STAFF REPORT
KETCHUM PLANNING AND ZONING COMMISSION
REGULAR MEETING OF SEPTEMBER 9, 2019

PROJECT: 220 Lava Street Single-Family Residence

FILE NUMBER: P19-085

APPLICATION TYPE: Mountain Overlay Design Review

A-4.1

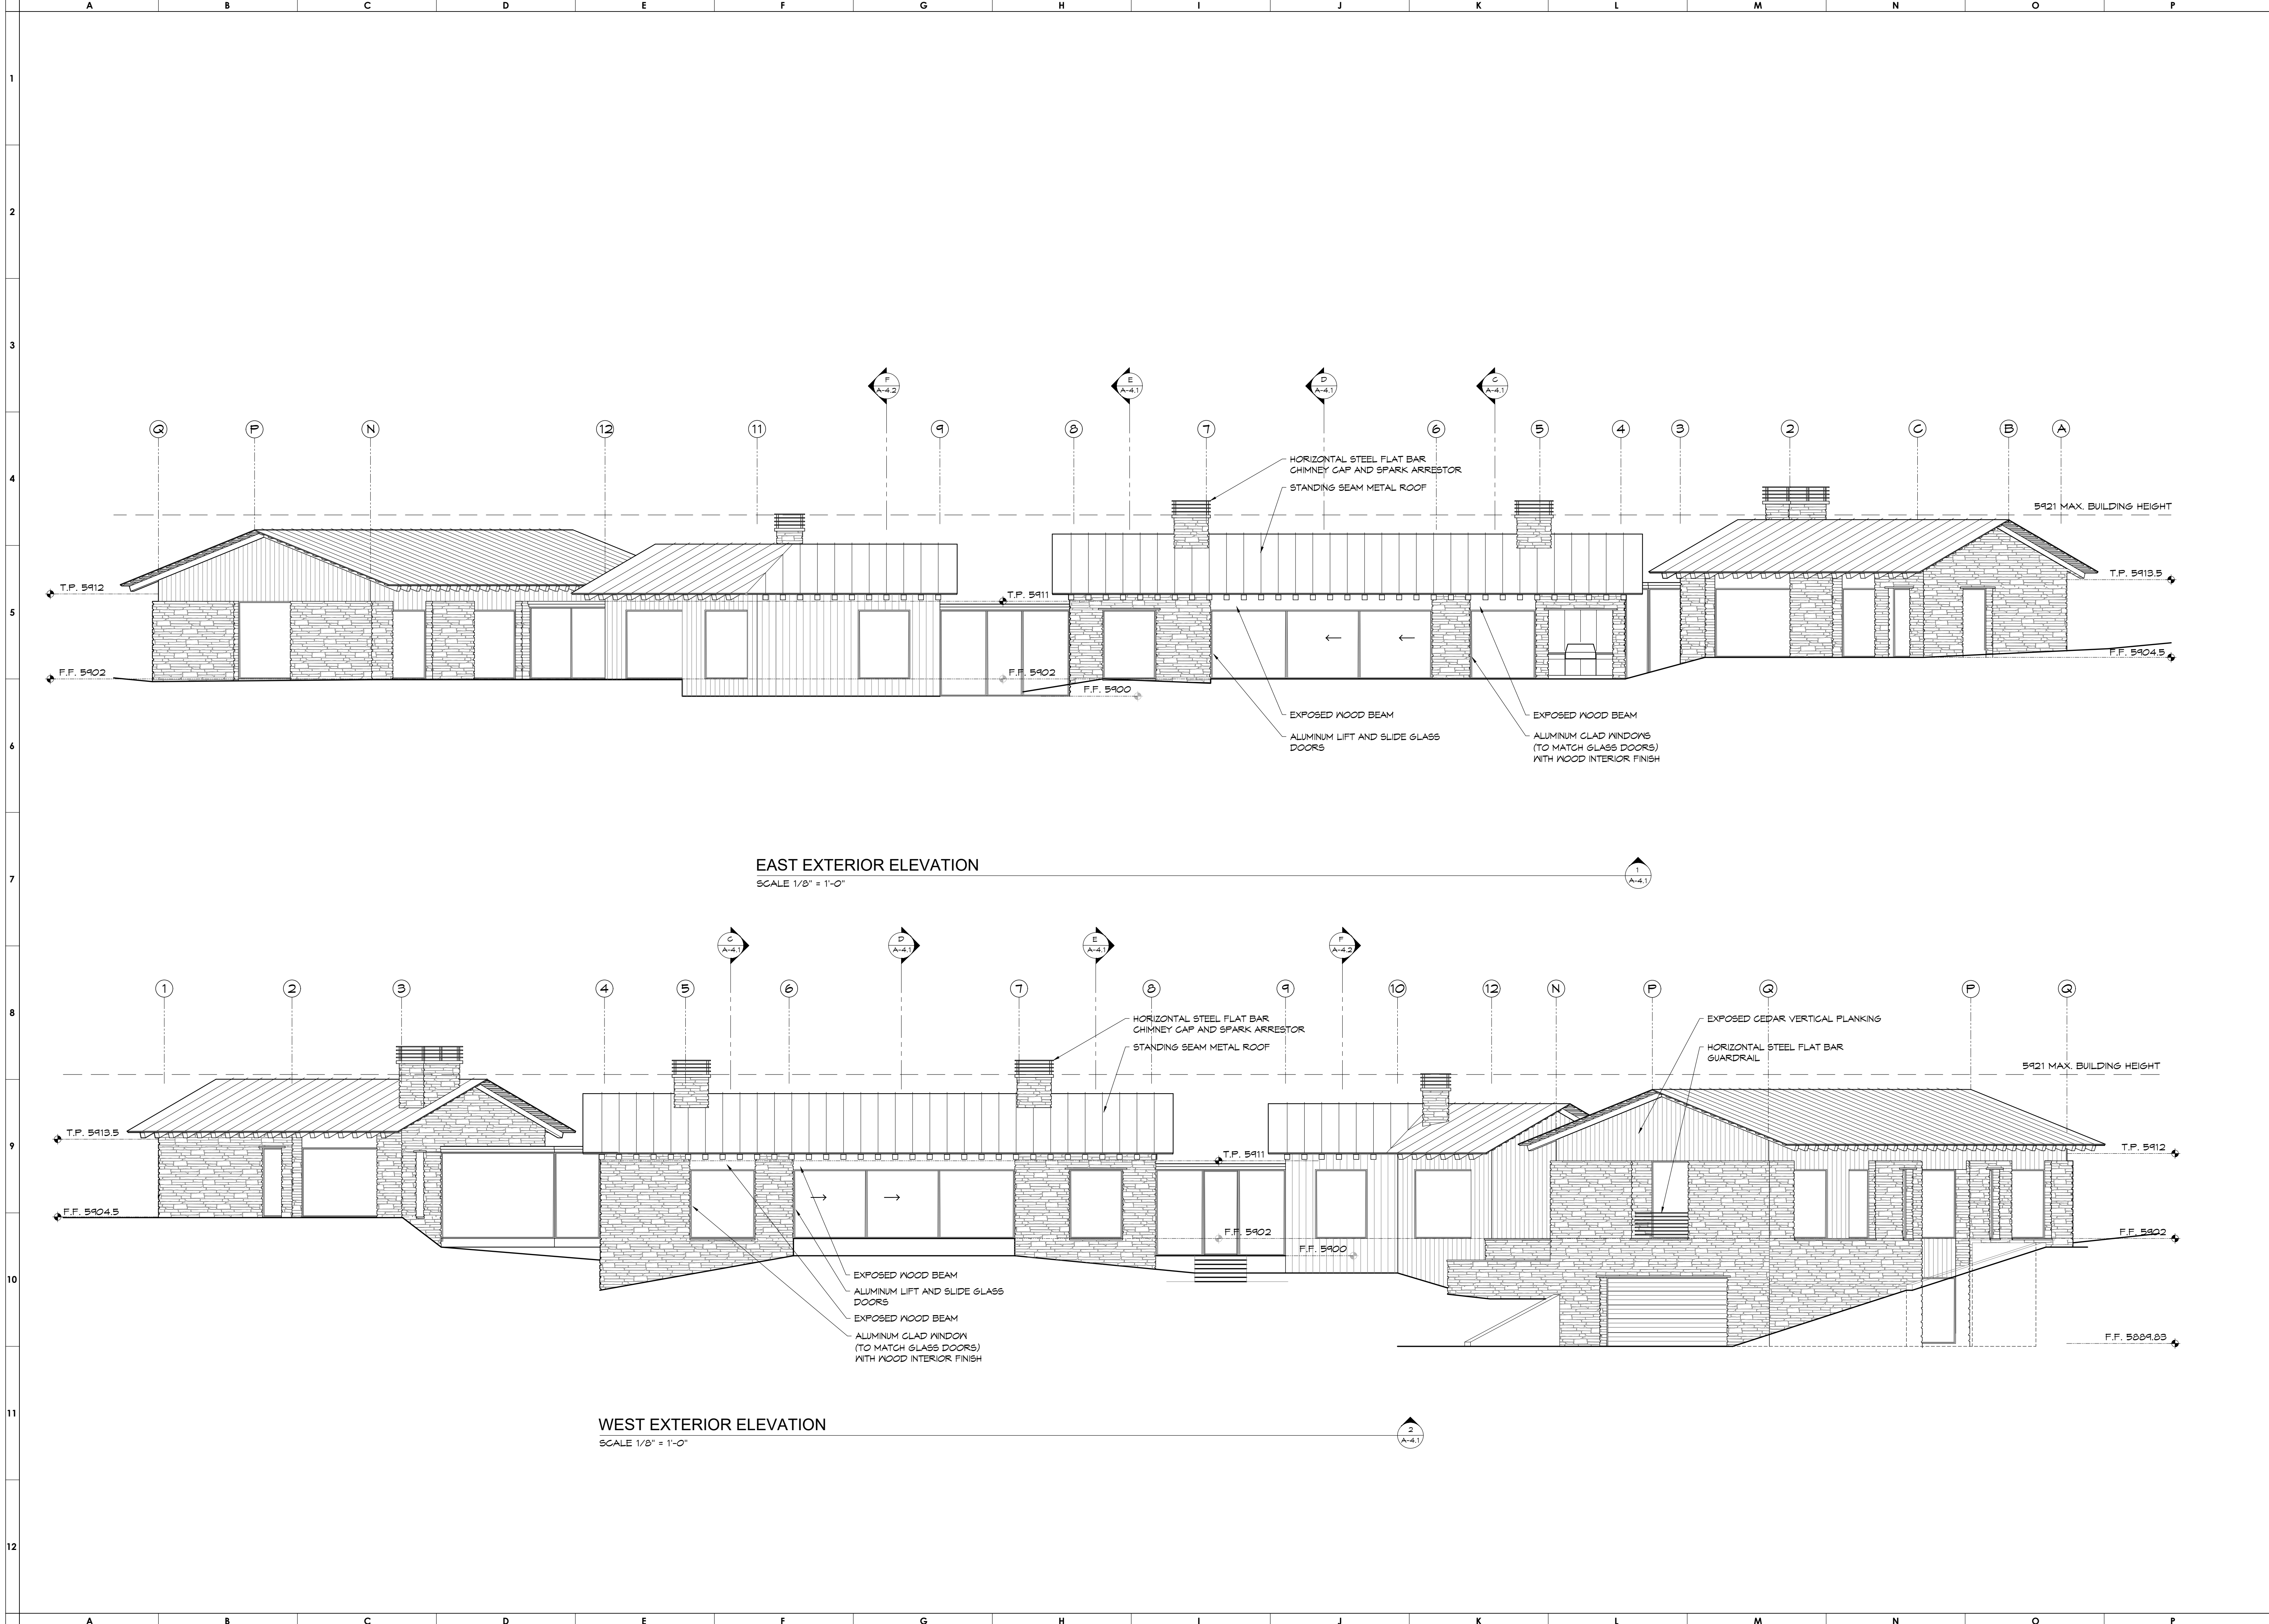
Staff Comment: As measured pursuant to KMC §17.08.020, the maximum building height of the proposed single-family residence is 31'-1". As indicated on Sheet A-4.1, the greatest vertical distance as measured from the lowest exposed finished grade at the garage (5889.89') to the roof ridge (5921') is 31'-1". While the 5921' elevation is referenced as a threshold maximum building height, the plat notes give the Planning & Zoning Commission discretion to further restrict building height through Mountain Overlay Design Review. Minimizing visual impact on the hillside through the use of natural materials and colors as well as the low-profile design, the proposed single-family residence exemplifies the intent of Mountain Overlay Design standards as the project complements the natural land features and preserves the hillside and ridgeline.

MATERIAL PALETTE

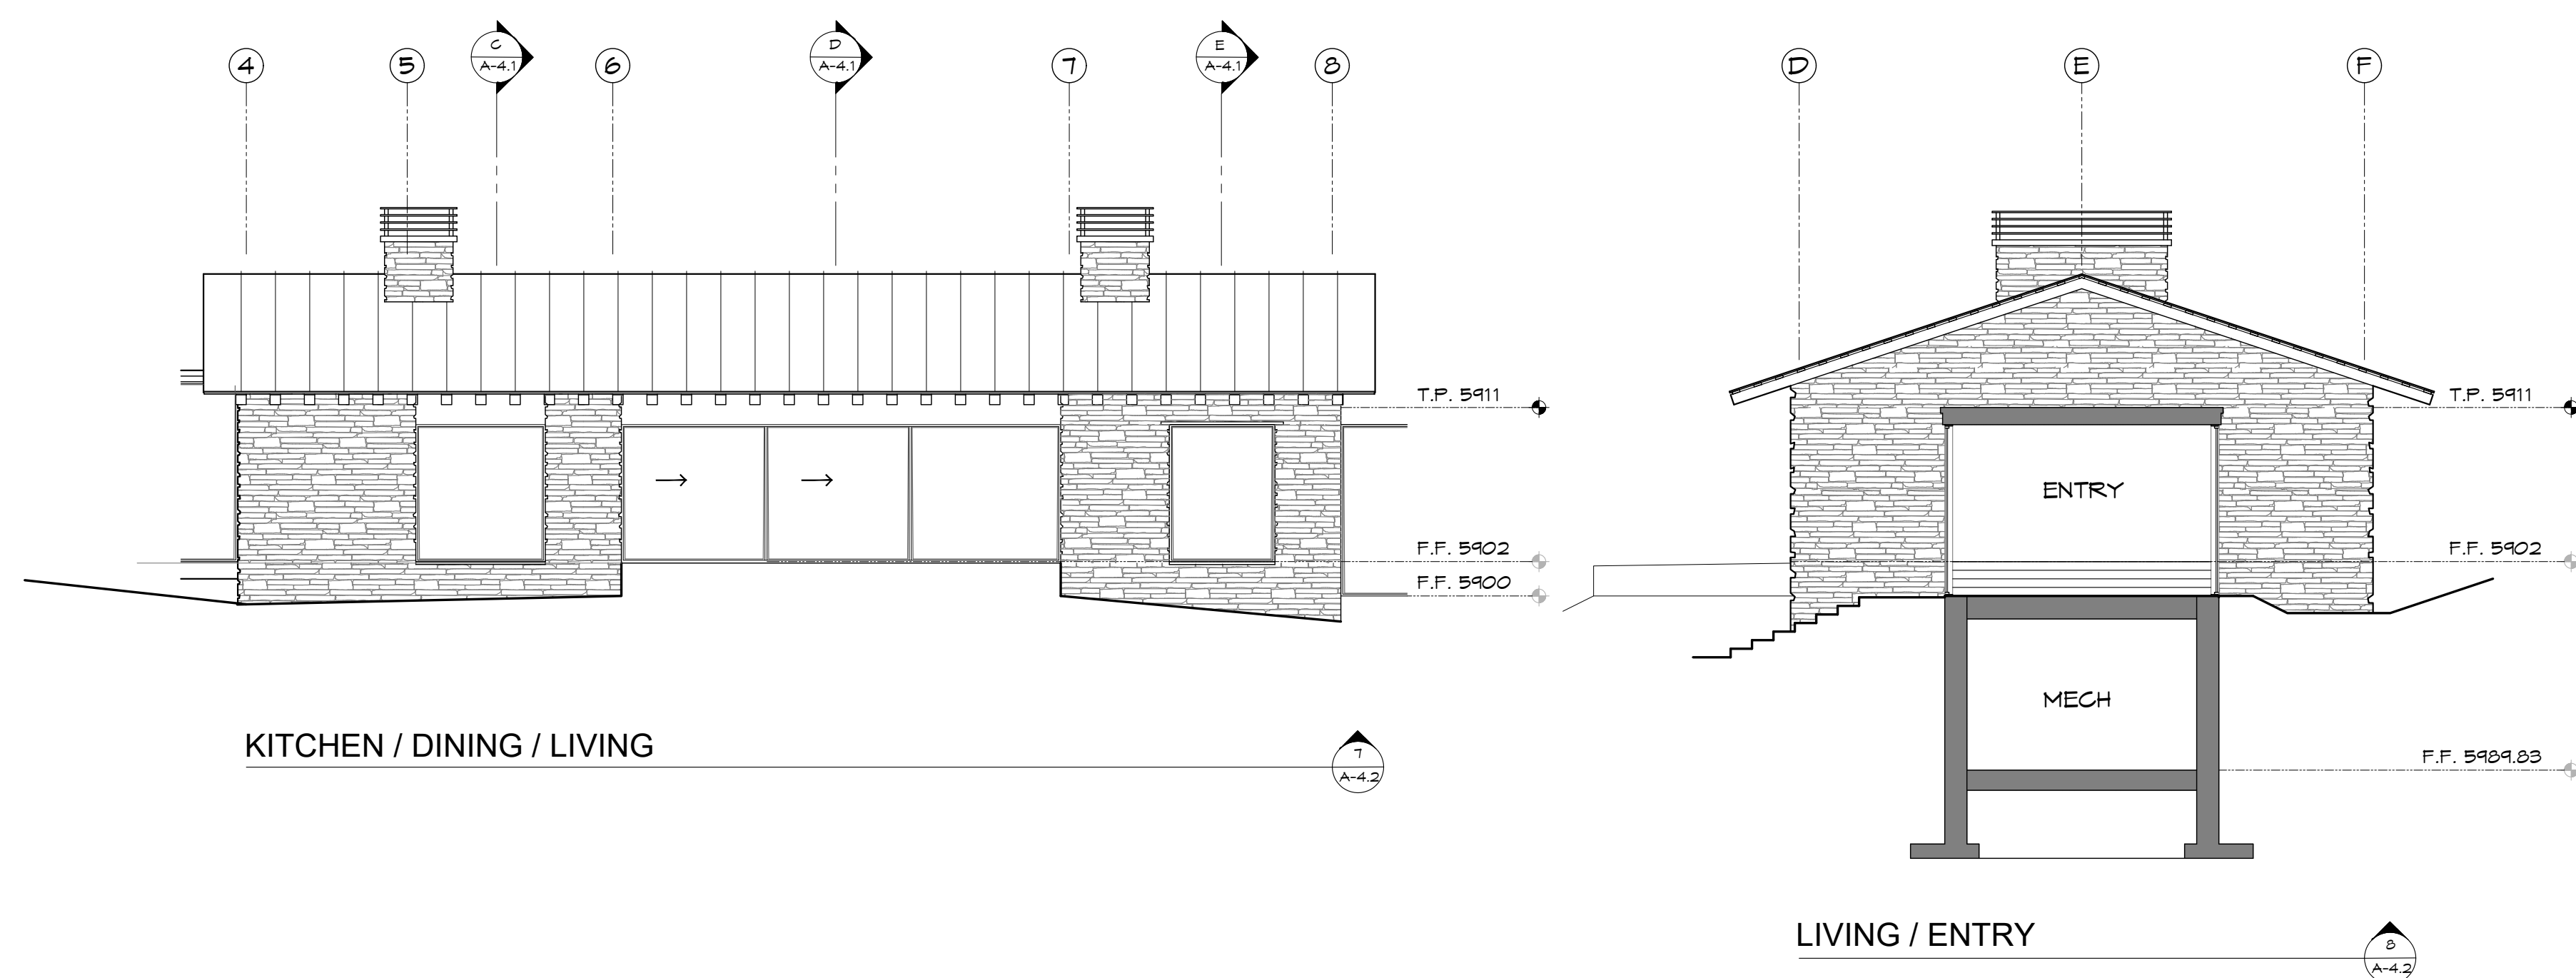
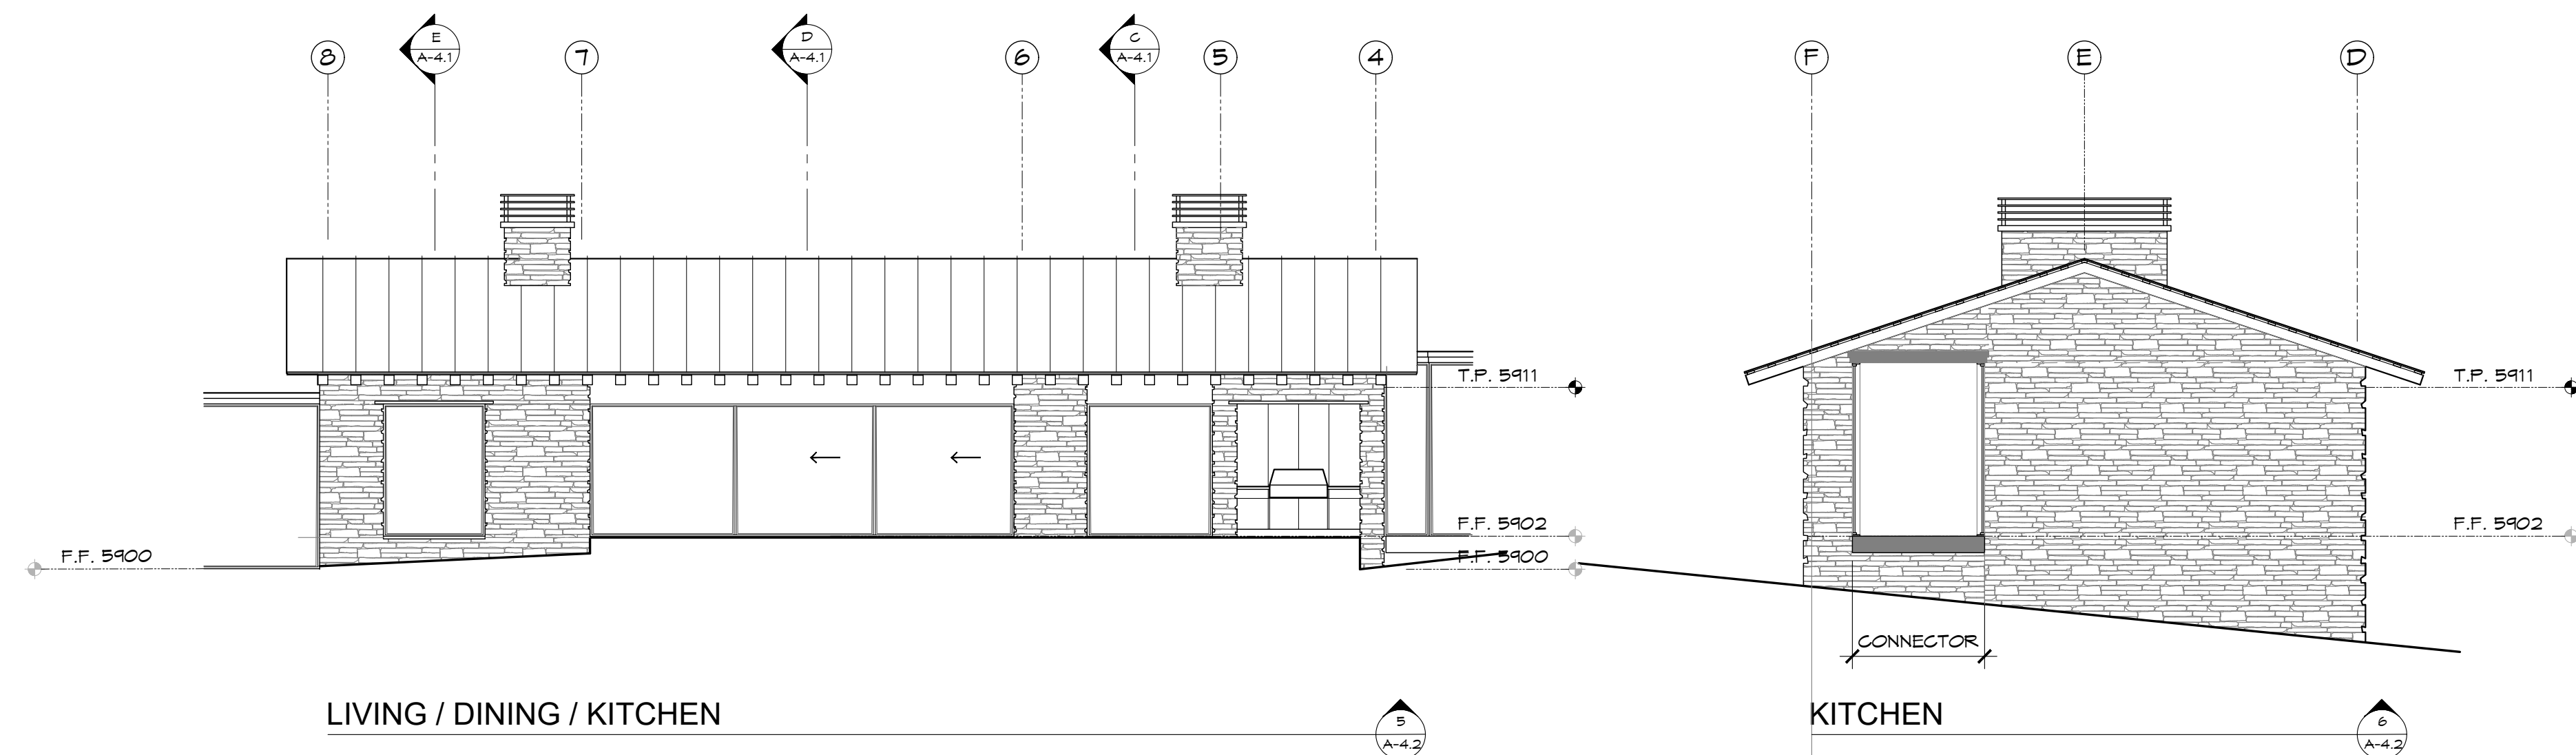
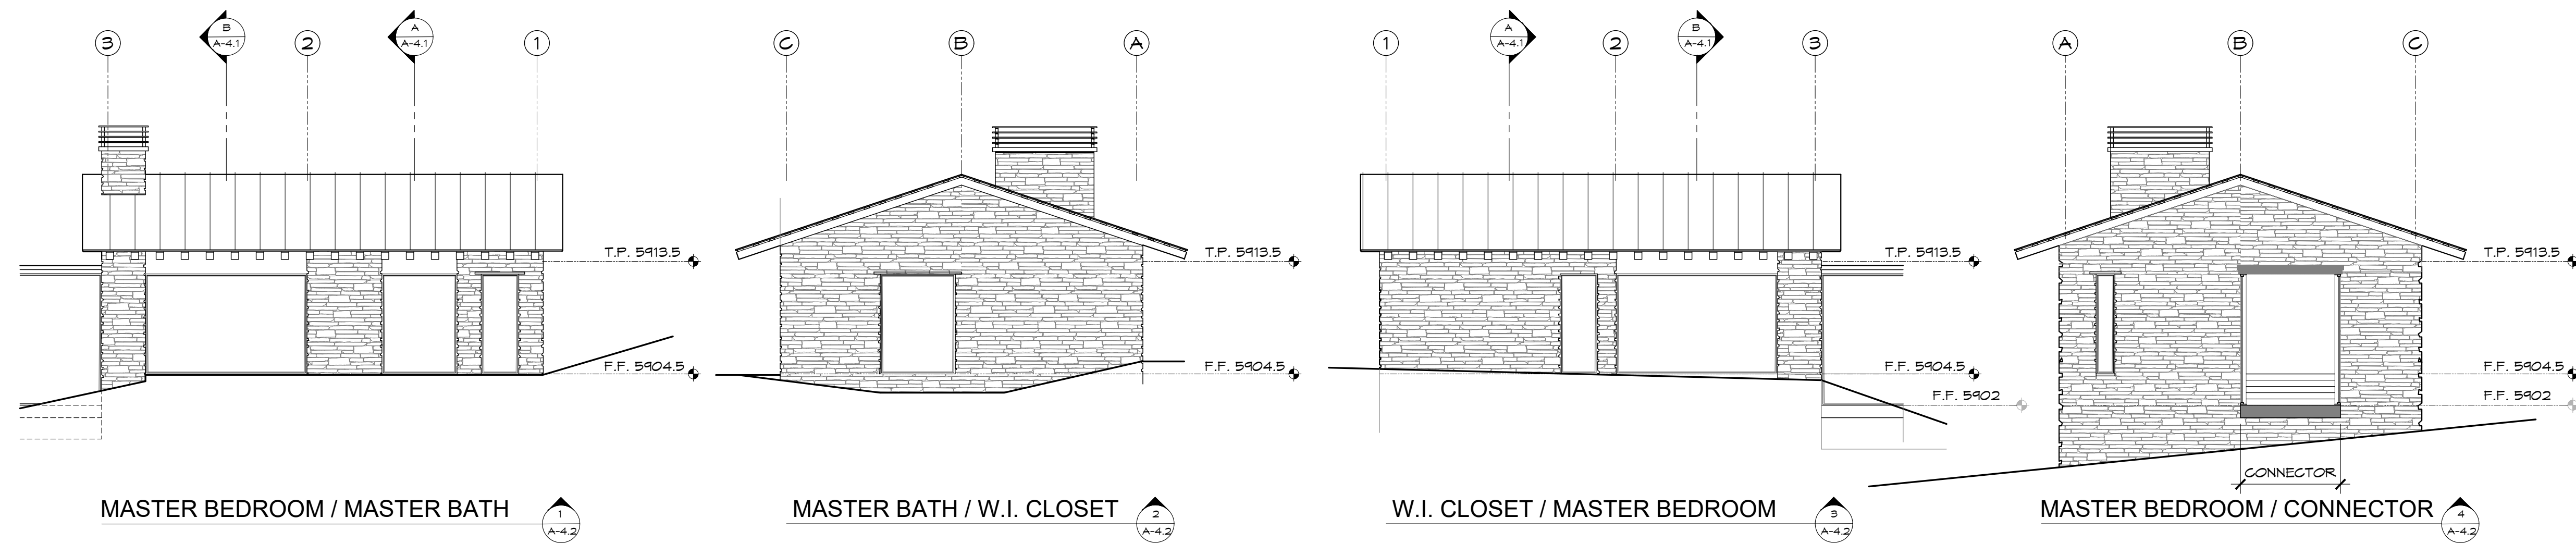
Staff Comment: The proposed material palette is included on Sheet A-4.5 of the MO Design Review submittal. Exterior materials include a charcoal standing seam metal roof, stone veneer, exposed cedar rafter tails and beams, finished cedar vertical planking and soffits, wood clad windows, steel lift and slide glass doors, as well as transparent glass connectors. Providing relief to each façade, the proposed fenestration celebrates the surrounding hillside as the window, door, and connector openings fully immerse the building within the landscape. Balancing this openness, the stone veneer, cedar siding, and charcoal metal roof articulate the facades and ground the building within the hillside. The natural materials and colors harmonize with the surrounding landscape.
